### Proposed Revisions to a Standard Plans Index

Index Number: 455-400

Index Title: Precast Concrete Sheet Pile Wall  
(Conventional)**Summary of the changes:**

**SECTION THRU BULKHEAD**  
(Showing Plastic Filter Fabric)

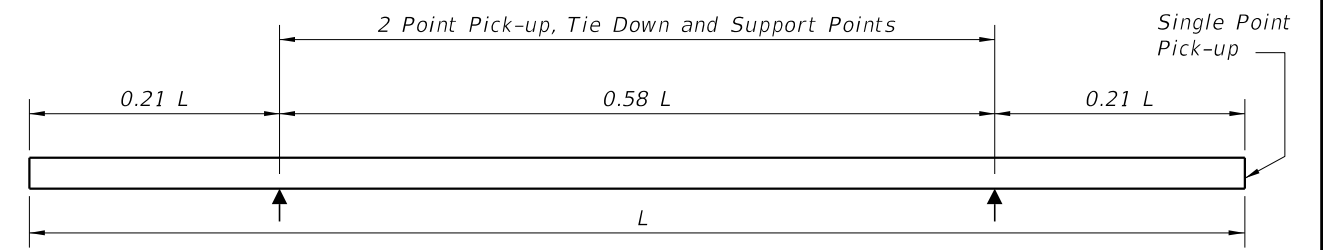
Sheet 1: Changed the "PLASTIC FILTER FRABRIC" Note in the SHEET PILE DESIGN CRITERIA AND NOTES to "GEOTEXTILE: Provide and install Type D-2 or D-3 geotextile in accordance with Specifications 514. Extend the geotextile to the bottom of the "X" dimension."; Changed all references of "Filter Fabric" or "Plastic Filter Fabric" to "Geotextile".

**CHANGED: Geotextile**

**CHANGED:**  
Provide and install Type D-2 or D-3 geotextile in accordance with Specifications 514. Extend the geotextile to the bottom of the "X" dimension.
